STAFF REPORT

Agenda Title: COA 23-40 - 63 Main Street

Requested Action: Review proposal for the request to install two window signs; one on the

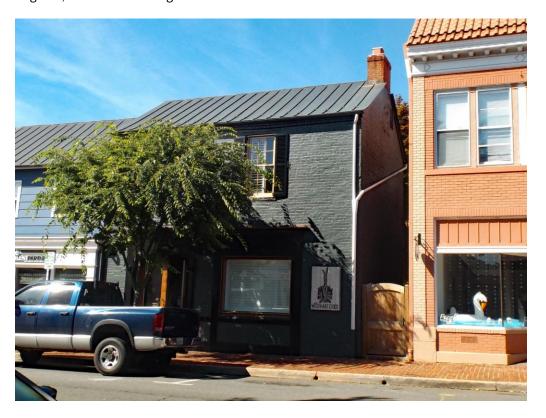
The applicant is proposing to install two new window signs.

- 1) One sign will be located on the door and the other on the window.
- 2) Both signs will include name of business and company logo.
- 3) Applicant confirmed both signs will comprise of less than 25% of the total window area.
- 4) Glass size is 82" x 571/2"
- 5) The "b" is 28" x 28"
- 6) The top line is 61" x 4\%"
- 7) The bottom line is 48" x 1½"

Historic District Guideline	Page No.	Analysis	
E. WINDOW SIGNS			
Window signs are a form of a wall sign and should be included in the permitted	3.40	Glass size is 82" x 57½"	
wall sign area. No window sign should exceed twenty-five percent (25%) of the		The "b" is 28" x 28"	
window area or have letters taller than twenty-four (24) inches. Glazed doors		The top line is 61" x 41/4"	
may also have lettering.		The bottom line is 48" x 1½"

Page No.	Analysis
3.40	Glass size is 82" x 57½"
	The "b" is 28" x 28" The top line is 61" x 41/4"
	The bottom line is 48" x 1½"
3.40	There will be no solid, painted background. Lettering will be white and gold.
	No. 3.40

Staff recommends approval of the request to install one 13" x 36" hanging sign to the existing bracket, as described and depicted within the application, provided the following conditions are met:

- 1) All necessary permits are acquired.
- 2) The "b" lettering shall be no taller than 24", as per Historic District Guidelines.
